**DHEC Response to NRC Staff Comments on: “Industrial Wastewater Closure Module For The Liquid Waste Tanks 5F and 6F F-Area Tank Farm, Savannah River Site,”
SRR-CWDA-2012-00071, Revision 0, January 2013**

Figure 3.1-32 (page 46) of SRR-CWDA-2012-00071, Rev. 0.

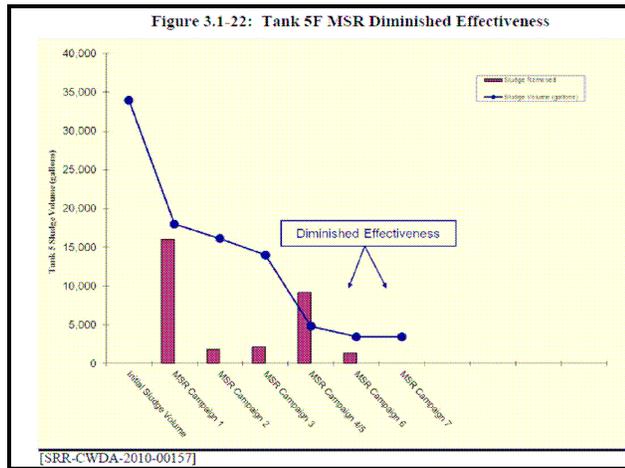
CC-1 SRR-CWDA-2012-00071, Rev. 0 (page 41) discusses the effectiveness of a 3rd SMP installed under Riser 1 in MSR Campaign 4 and 5. It is not clear why the addition of the 3rd SMP under Riser 1 was not as effective in MSR Campaign 3 and suddenly became effective essentially in MSR Campaign 5 (Campaign 4 was curtailed due to a tornado watch). See figure below. It would be helpful for DOE to comment on the uncertainty in the heel estimates and if the uncertainty could partially explain the relative effectiveness of MSR Campaign 5 compared to Campaign 3. Any additional insights on the increased effectiveness of Campaign 5 compared to Campaign 3 would be helpful.

RESPONSE CC-1:

Based on clarification from DOE, during the 3rd campaign, there was an issue with cooling in the tank and the SMPs had to be slowed down. There was also an electrical issue with one of the SMPs that required it to be shut down prematurely. During the transfer with the other 2 SMPs running, the tank temperature reached the maximum for SMP operation and required the 2 operating SMPs to be shut down earlier in the transfer sequence than desired. Sludge was mounded under the first pump shutdown. **During the 4th and 5th campaign, all three SMPs ran without issue for the required duration.**
